Re: **Report on 1997 Red River Floodway Operations**

**Report on the**

**1997 Red River Floodway Operations**

**December 18, 1997**

Figure 1. 1997 Flood: Red River

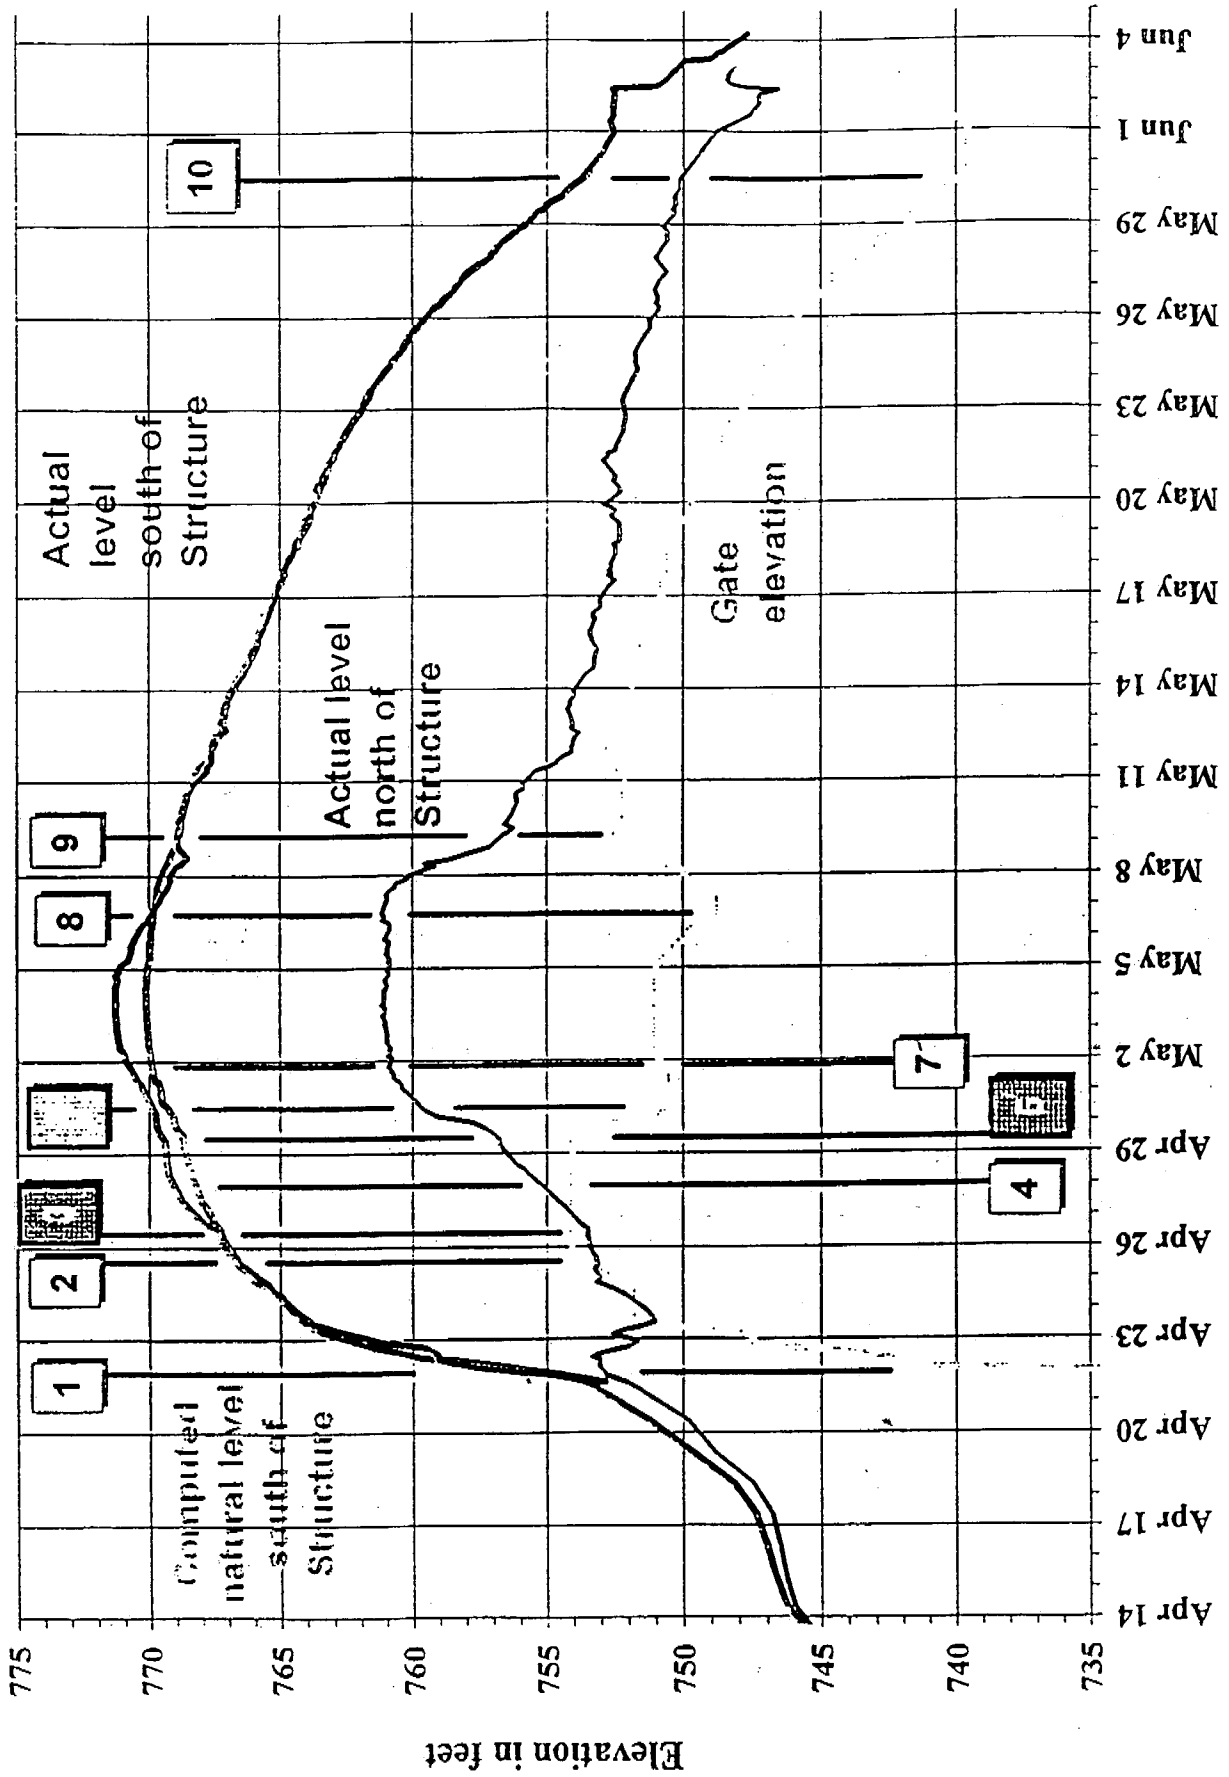
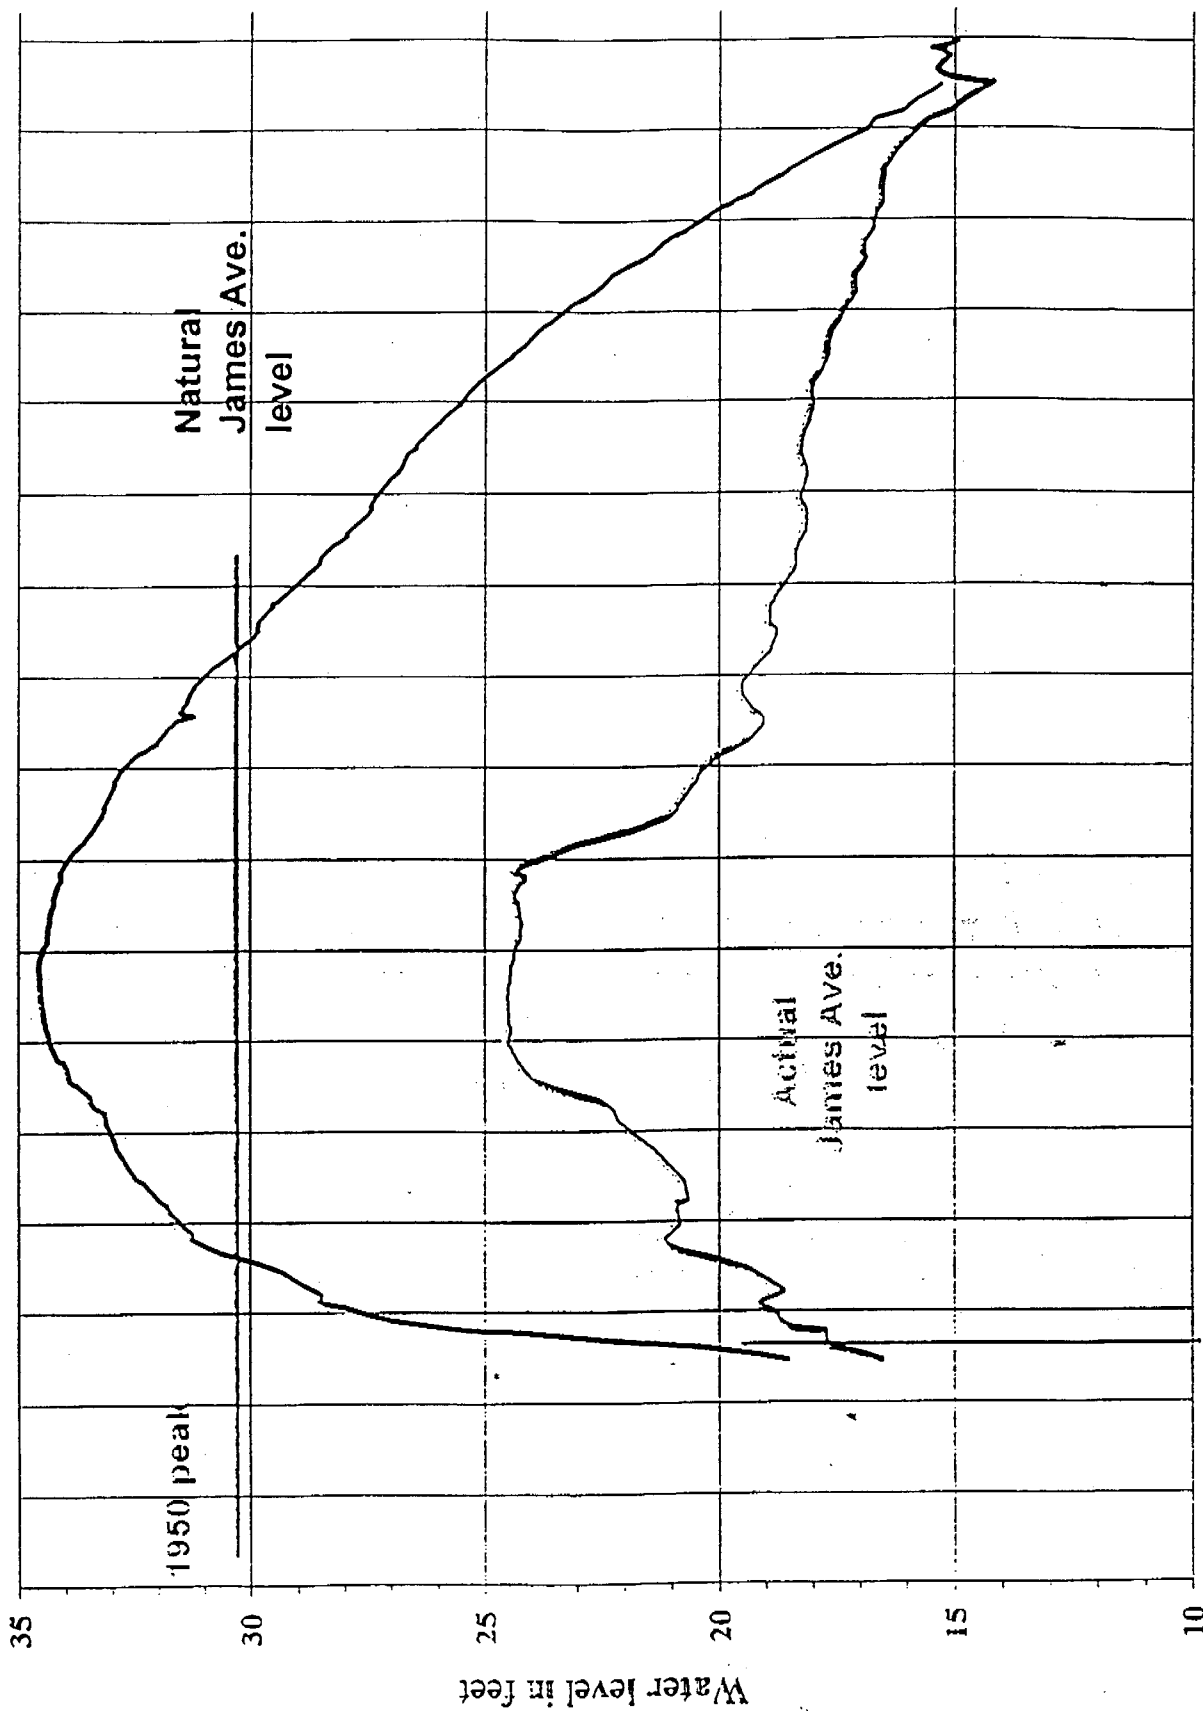
In 1997 the peak level, without flood control facilities, would have been 34.5 feet according to Figure 1 (following page) in the Submission to the Manitoba Water Commission, September, 1997. On line 1 of Table 5 this corresponds to a discharge of 160,610 cfs (4,548 cms), about the same as the 1852 estimated peak discharge that was calculated in the 1950's (Govt. Canada, 1953, Appendix D, Table 1, p. 8).

Figure 1 shows that the corresponding "natural" water level upstream of the Floodway would be approximately elevation 770.0<sup>2</sup>. On line 2 of Table 5, the 34.5 foot stage corresponds to a discharge of about 150,000 cfs. However, based on the rating curve in the 1953 Federal Government report, the maximum discharge would have been approximately 134,000 cfs. Thus, line 2 of Table 5 does not correspond to the rating curve developed in the 1953 Federal Government investigation and included in the 1970 Program of Operation. According to Figure 10 of the 1970 Program of Operation, the water level upstream corresponding to 134,000 cfs would be elevation 768.0, or two feet lower than the "natural" water elevation 770.0 shown on Figure 1.

Figure 1 and 1a are reproduced from the September 1997 Manitoba Natural Resources submission. The figure shows the estimated "natural" water levels upstream from the Floodway, compared to the water levels resulting from operation of the Floodway system. It can be seen that the observed water levels exceeded the calculated "natural" water levels at the peak of the flood over a period of approximately 72 hours. During most of this time, the water level was maintained approximately eighteen inches higher than "natural".

3. Flooding upstream from the Inlet Control Structure exceeded "natural" levels during the 1997 flood. Figure 1, which is a copy of the figure plotted by the Water Resources Branch of Manitoba Natural Resources for the Manitoba Water Commission, shows that south of the Inlet Control Structure flooding was sustained approximately 72 hours at 1.5 feet above the "natural" level. In the Grande Pointe area, this corresponds to at least 1.9 feet above the "natural" level.
